Rezoning Transportation Analysis

Petition Number: 2018-058

Date	Description
05-18-19	First Review

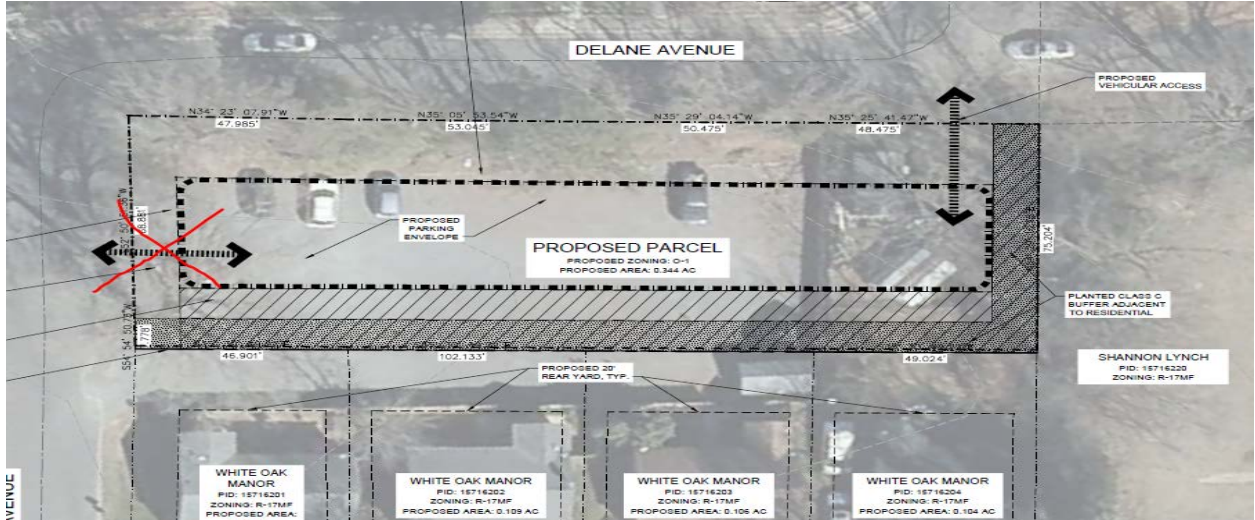
- ~~1. **Traffic Study** A Traffic Impact Study/Transportation Technical Memorandum is not necessary for the complete review of this petition.~~
- ~~2. The petitioner should revise the site plan and conditional note(s) to add curb and gutter along the frontage on Delane Avenue.~~ **Petitioner should change site plan note to have 2'6" C&G instead of just 2' as shown.**
